SUBJECT: Forwards revised listing of responses to App R Concern 1, explanation of each rev & revised Concern 1 sheets. Rev include reanalysis of Fire Zones 1-5B, 2-5B, 1-5A & 2-5A.

SUSQUEHANNA STEAM ELECTRIC STATION  
APPENDIX R - NRC CONCERN 1 RESPONSE - REVISION  
ER 100450 FILE 841-2  
PLA-2574

CONCERN #1

SUSQUEHANNA STEAM ELECTRIC STATION - UNITS 1 & 2  
FIRE PROTECTION PROGRAM - CONCERN #1  
DOCKETS NO. 50-387  
50-388

FIGURE 3.0

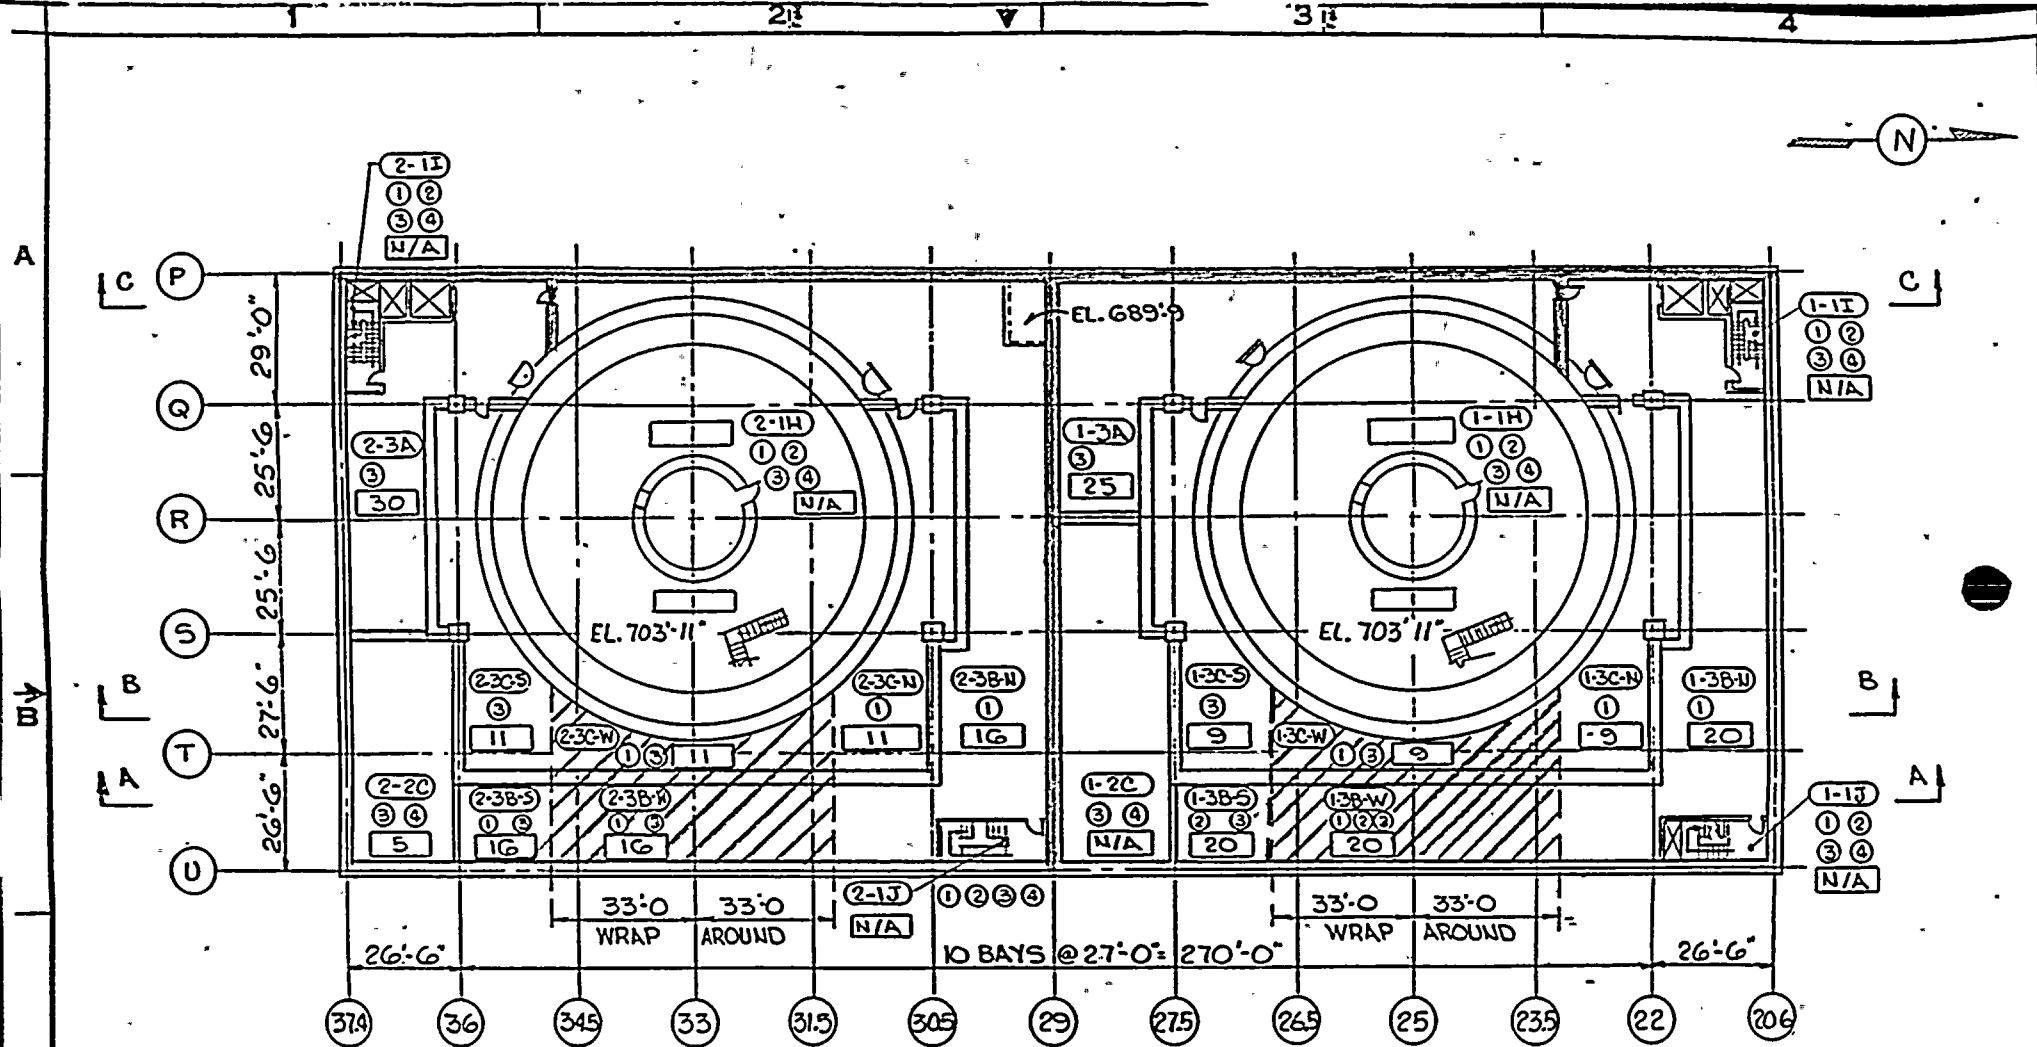
<u>Figure</u>	<u>Zone</u>	<u>Change</u>
2.0	2-1E	Path 2 Removed
3.0	1-3B-N 1-3A 2-3A	Path 2 Removed Path 4 Removed Path 4 Removed
4.0	1-4A-S 1-4A-W 1-4C 1-4D 2-4A-S 2-4A-W 2-4C 2-4D	Path 4 Removed Path 2 Removed Path 2 Removed Path 4 Removed Path 4 Removed Path 2, 4 Removed Path 2 Removed Path 4 Removed
5.0	1-5B  2-5B	Path 1 Removed Wall & Floor to Fire Zone 1-4G Upgraded Wall to Fire Zone 2-5A-N Upgraded
6.0	2-6A	Floor to Fire Zone 2-5B

SCALE: NOD  
 FIGURE 11.

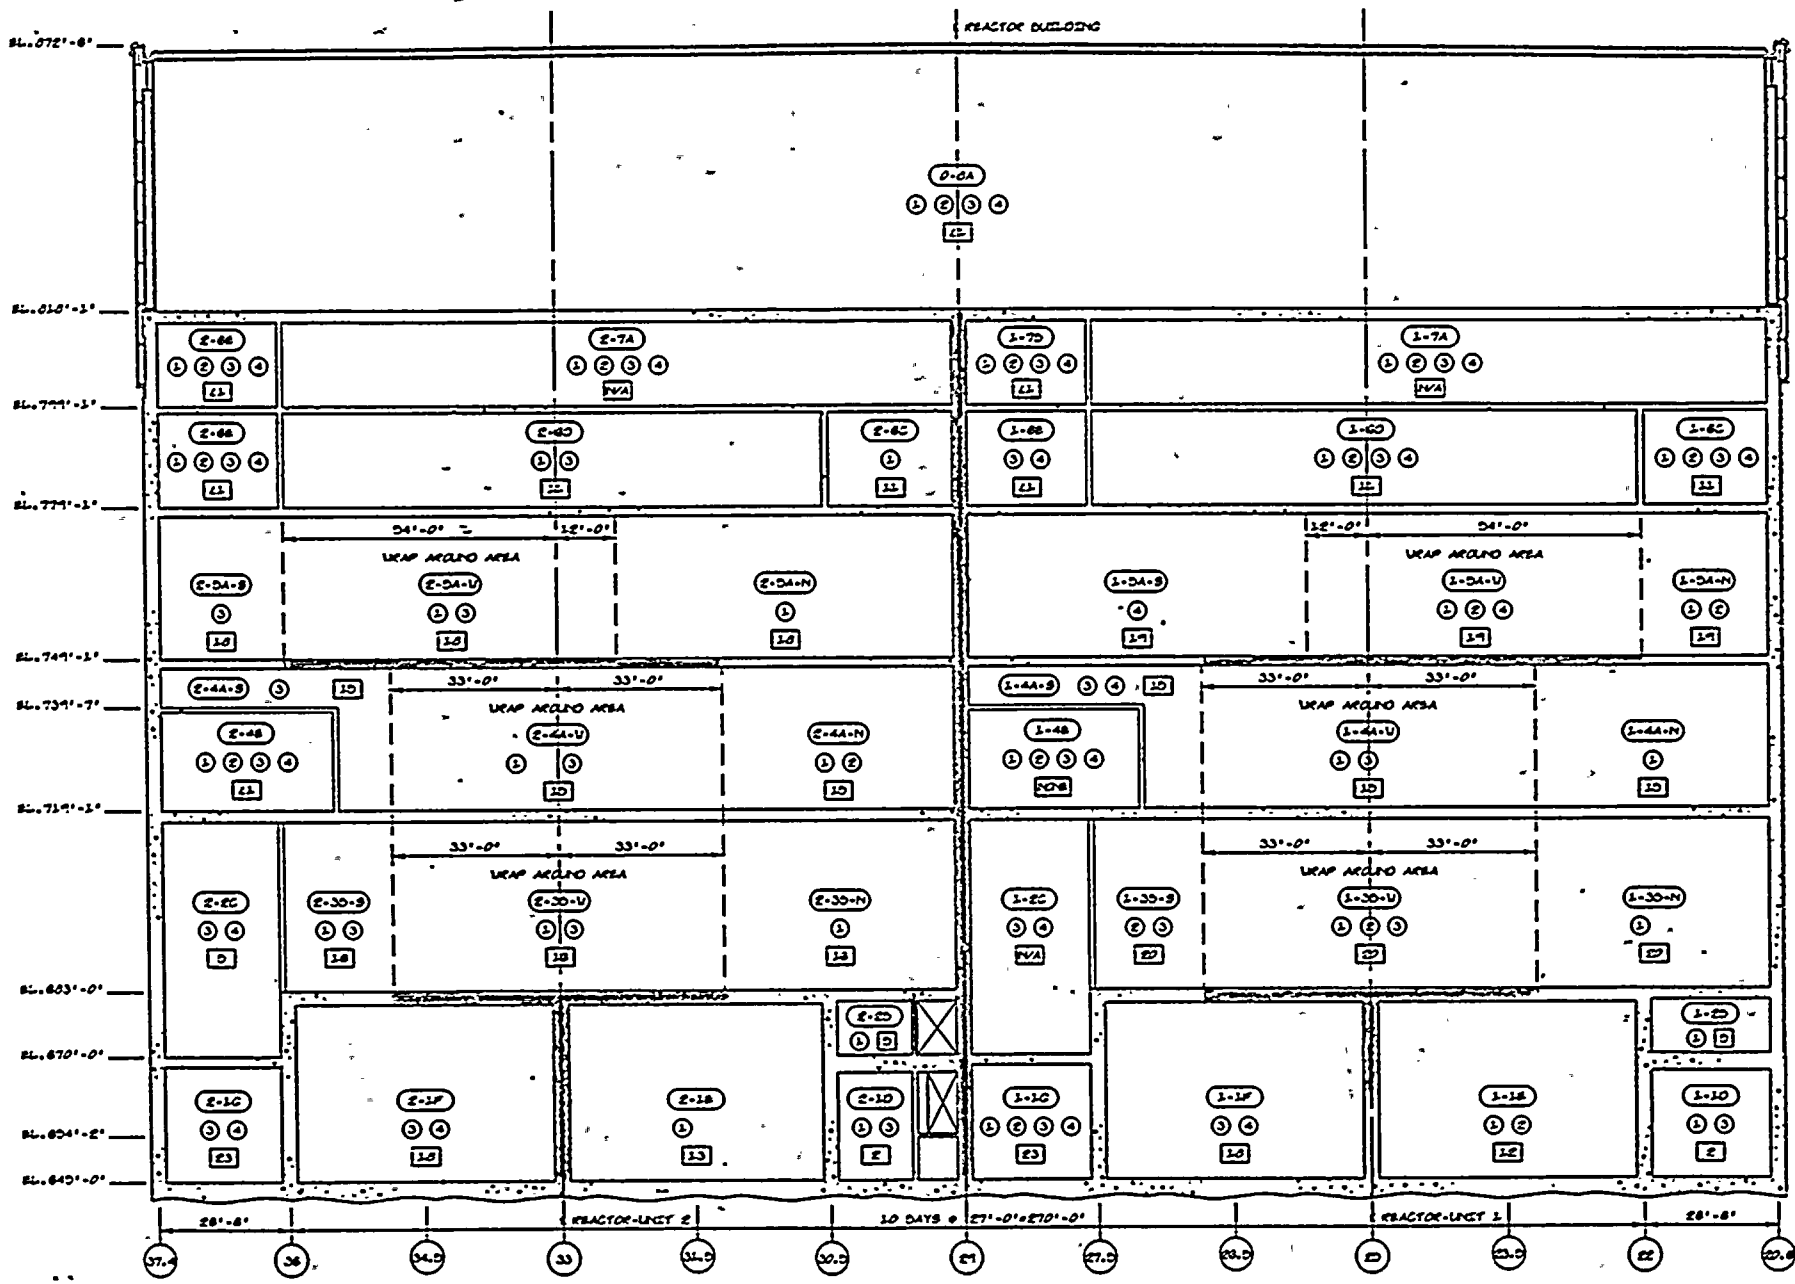
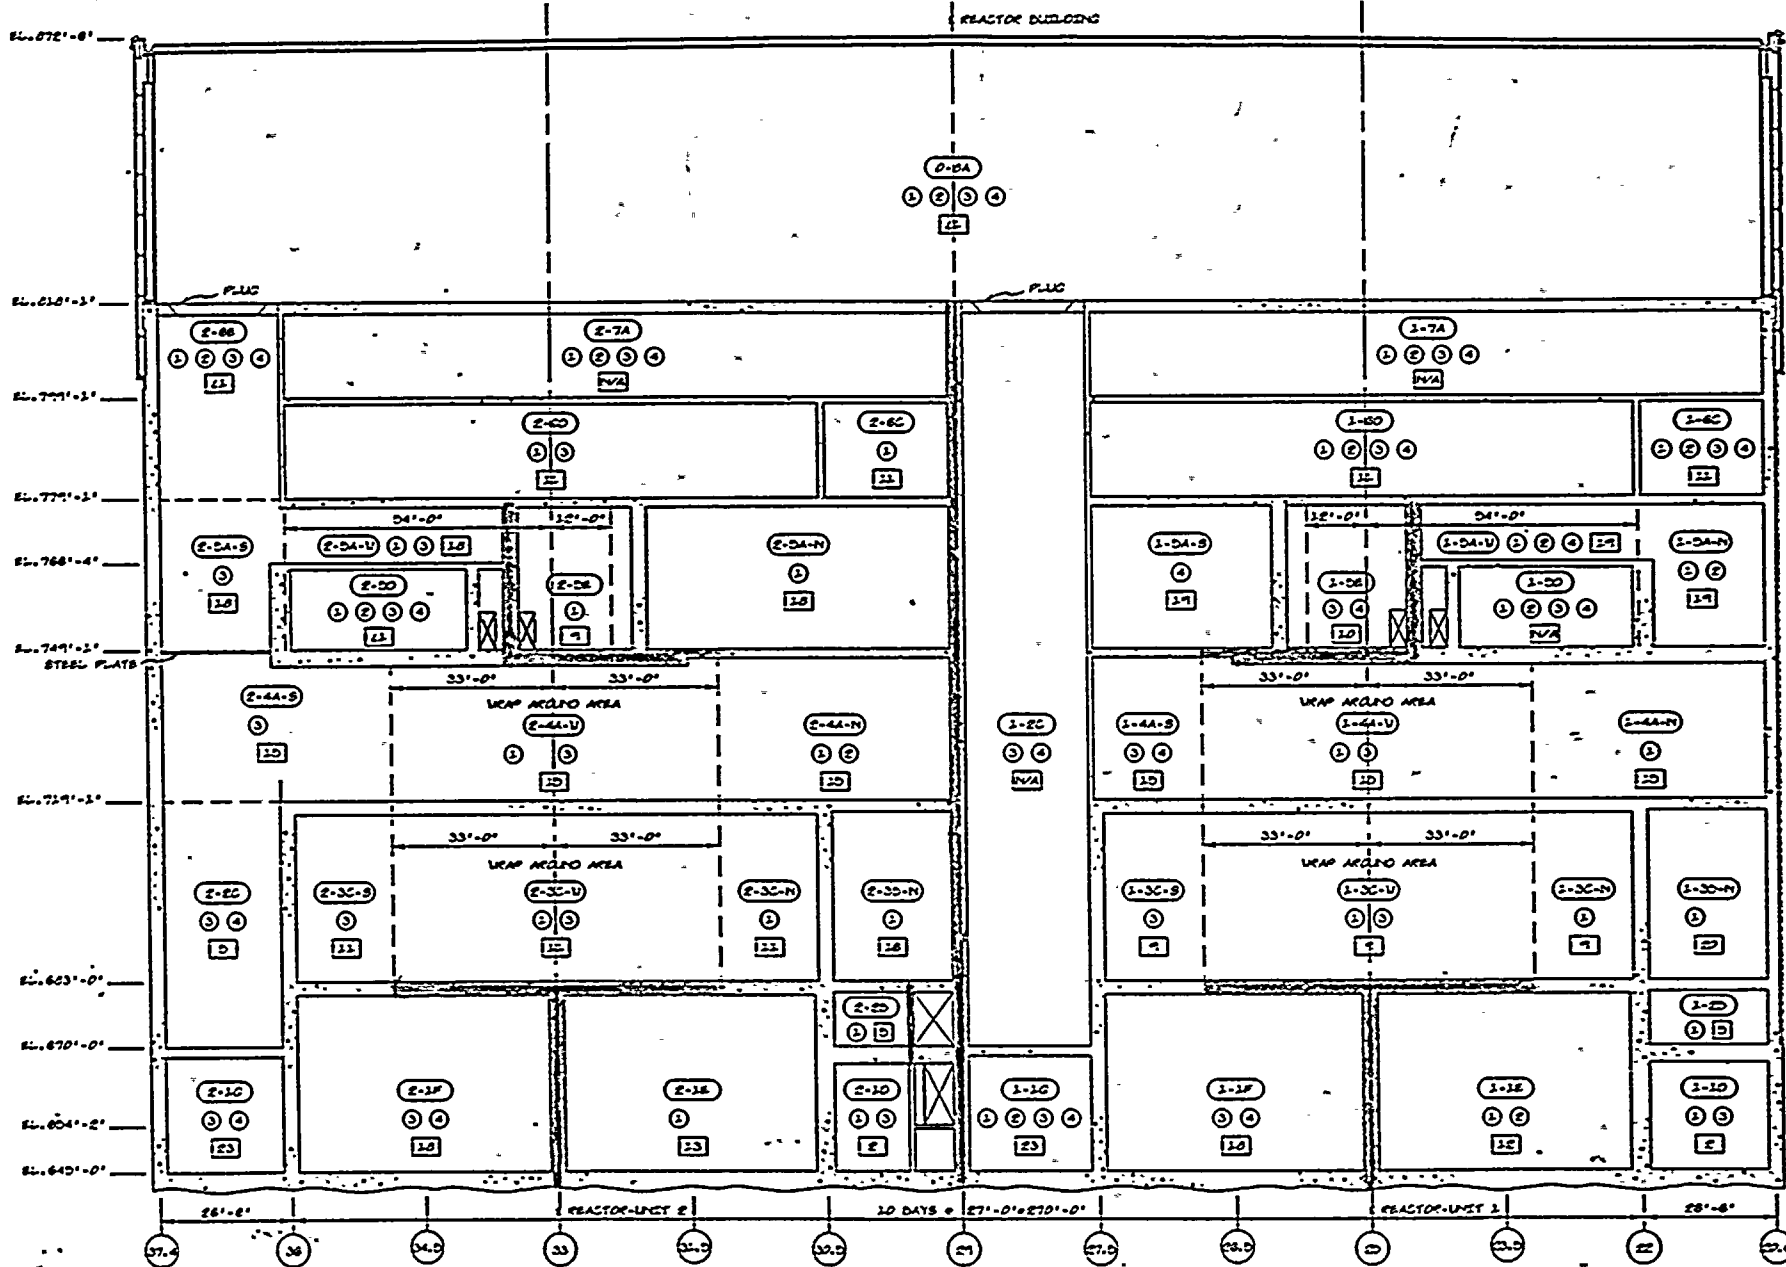
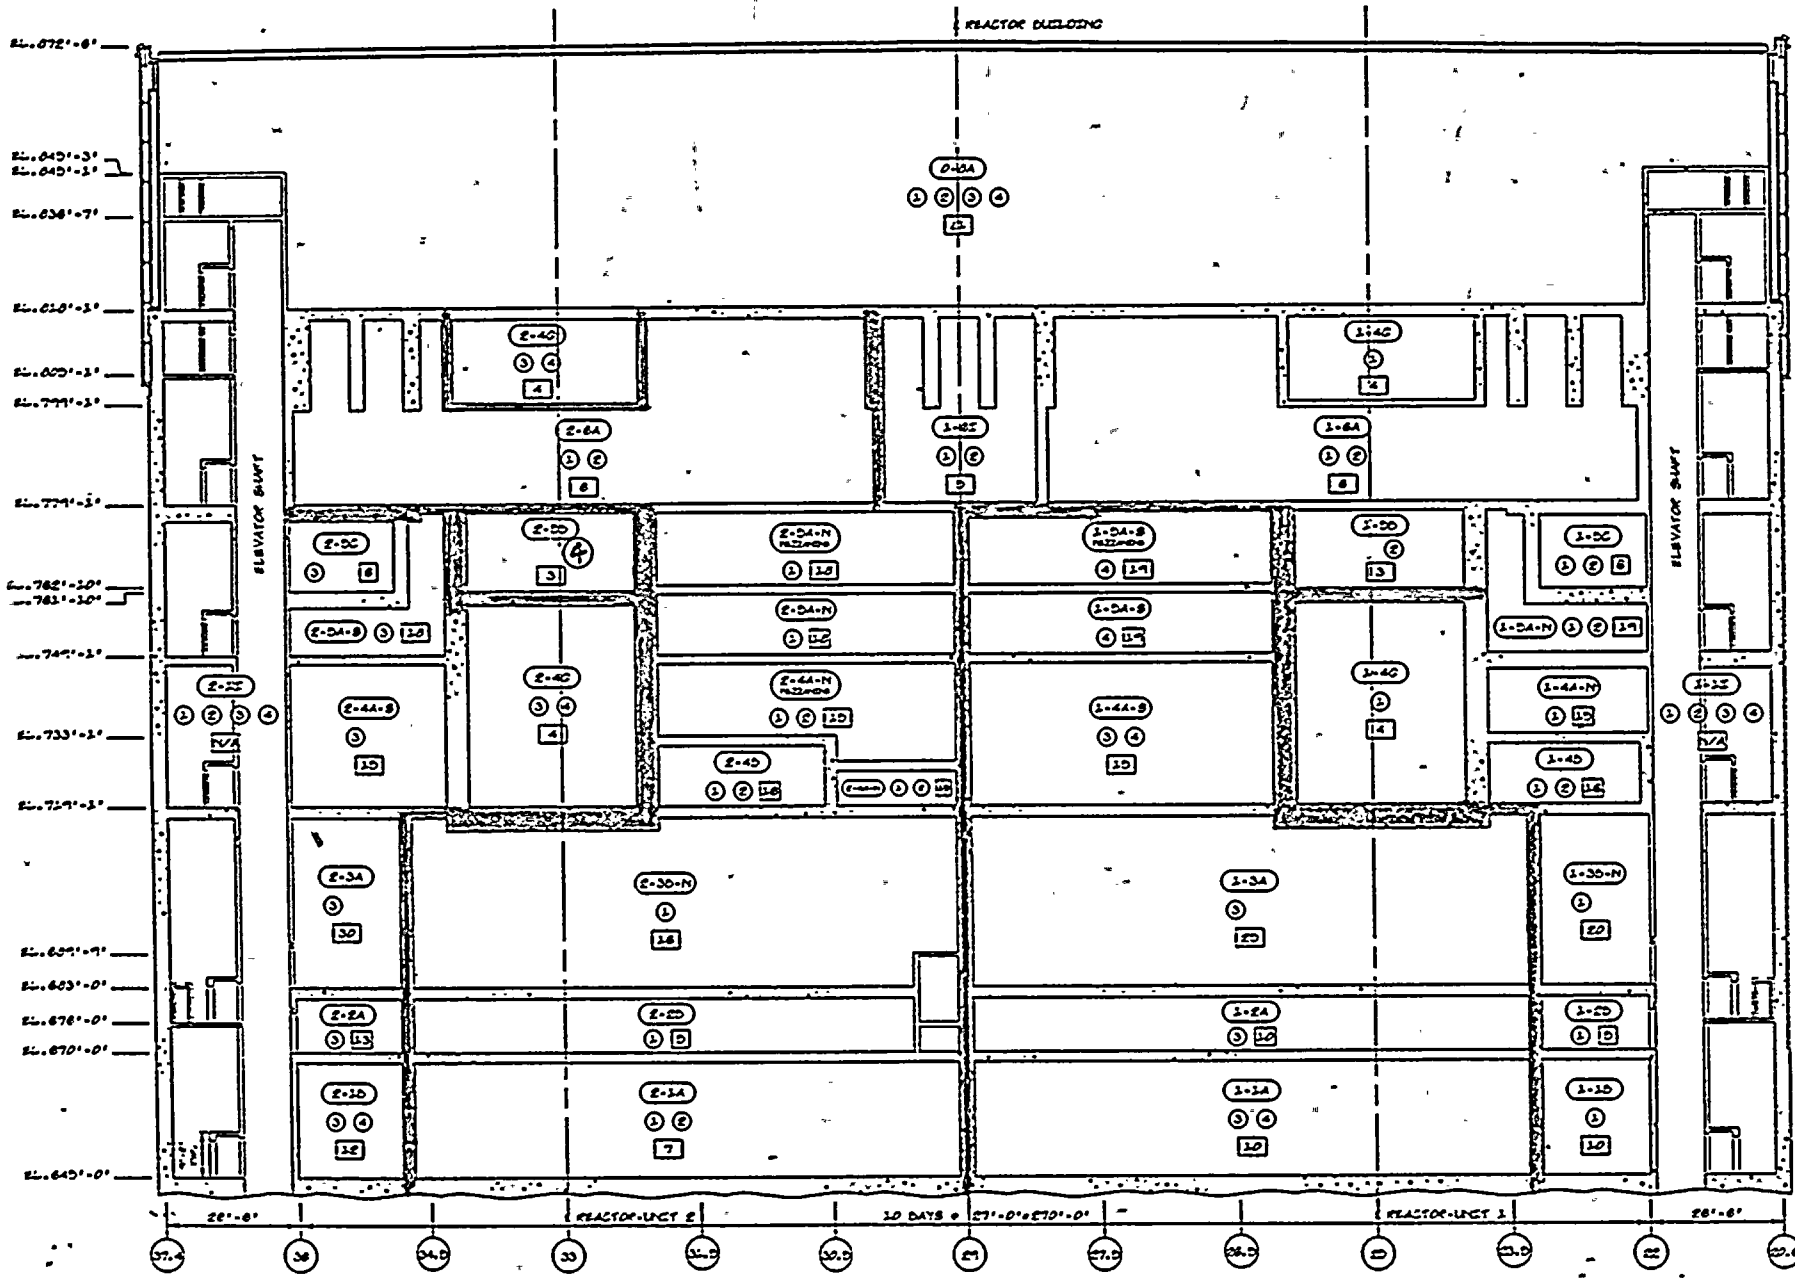
9, 10, 11 Section views reflect changes to Fig. 2.0, 3.0, 4.0, 5.0 6.0
